Project	IEEE 802.16 Broadband Wireless Access Working Group < http://ieee802.org/16 >
Title	Procedures Clarifications and Improvement for MBS Logical Channel support in 802.16REV2
Date Submitted	2008-05-08
Source(s)	<p>mailto:</p> <p>Jonathan Segev, Comsys jonathan.segev@comsystemobile.com</p> <p>Tricci So, ZTE tso@zteusa.com</p> <p>Jerry Chow, ZTE jchow@zteusa.com</p>
Re:	P802.16Rev2/D4, LB26c
Abstract	The current definition of Logical Channel support for MBS has deficiencies in the areas of CS classification and CS SAP, and in the support for packing and robustness in the presence of MAC header detection errors for multi-PDU MBS bursts on the MAC data path.
Purpose	Adoption toward REV2/D5
Notice	<i>This document does not represent the agreed views of the IEEE 802.16 Working Group or any of its subgroups.</i> It represents only the views of the participants listed in the "Source(s)" field above. It is offered as a basis for discussion. It is not binding on the contributor(s), who reserve(s) the right to add, amend or withdraw material contained herein.

Procedures Clarifications and Improvement for MBS Logical Channel support in 802.16REV2

Figure 9—MAC SDU format

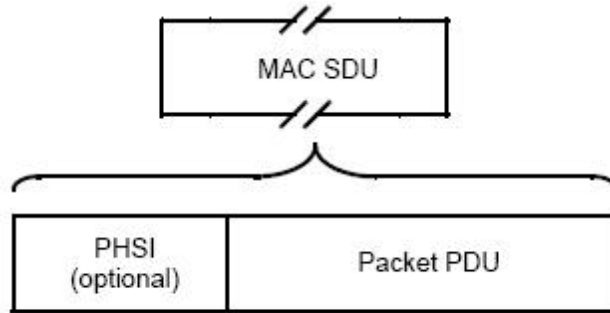
Once classified and associated with a specific MAC transport connection and if applicable, with a specific logical channel within an MBS transport connection, higher layer PDUs shall be encapsulated in the MAC SDU format as illustrated in Figure 9. The 8-bit PHSI (payload header suppression index) field shall be present when a PHS rule has been defined for the associated connection.

Figure 10—Classification and CID mapping (BS to SS)

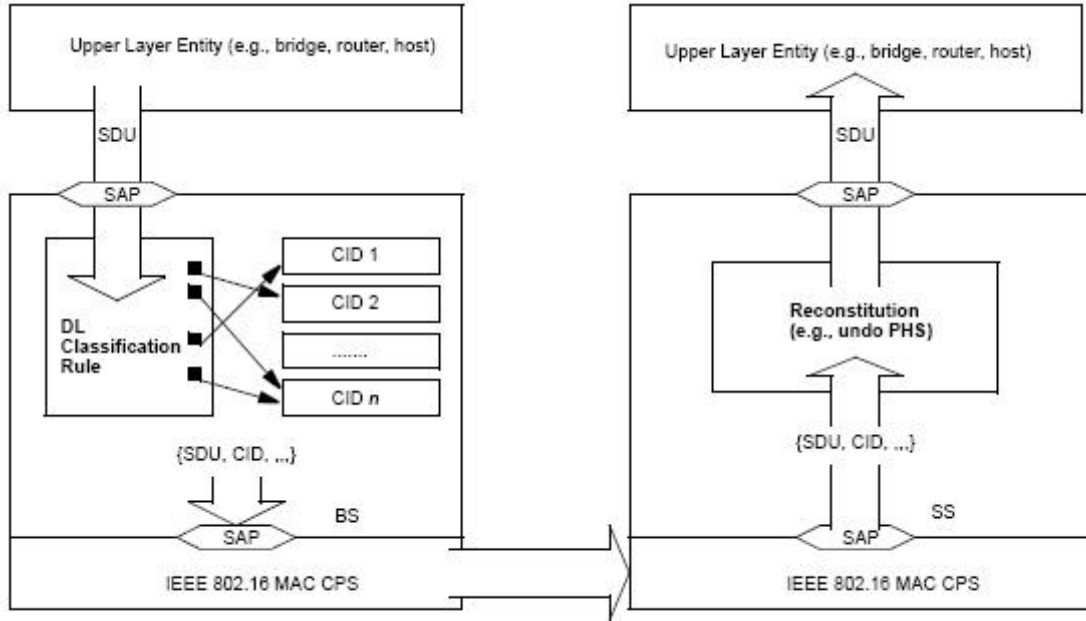
Classification is the process by which a MAC SDU is mapped onto a particular transport connection or onto a particular logical channel within an MBS transport connection for transmission between MAC peers. The mapping process associates a MAC SDU with a transport connection or a logical channel of an MBS transport connection, which also creates an association with the service flow characteristics of that connection. This process facilitates the delivery of MAC SDUs with the appropriate QoS constraints.

A classification rule is a set of matching criteria applied to each packet entering the IEEE 802.16 network. It consists of some protocol-specific packet matching criteria (destination IP address, for example), a classification rule priority, and a reference to a CID and if applicable, to a Logical Channel ID of an MBS transport connection. If a packet matches the specified packet matching criteria, it is then delivered to the SAP for delivery on the connection defined by the CID or on the logical channel, defined by the Logical Channel ID of an MBS transport connection by the multicast CID. Implementation of each specific classification capability (as, for example, IPv4 based classification) is optional. The service flow characteristics of the connection provide the QoS for that packet.

Several classification rules may each refer to the same service flow or in the case of an MBS service flow with separate contents identified by MBS Content IDs, to the same MBS content associated with an MBS Content ID. The classification rule priority is used for ordering the application of classification rules to packets. Explicit ordering is necessary because the patterns used by classification rules may overlap. The priority need not be unique, but care shall be taken within a classification rule priority to prevent ambiguity in classification. DL classification rules are applied by the BS to packets it is transmitting and UL classification rules are applied at the SS. Figure 10 and Figure 11 illustrate the mappings discussed in the previous paragraph based on the scenario when classification is applied to a CID.
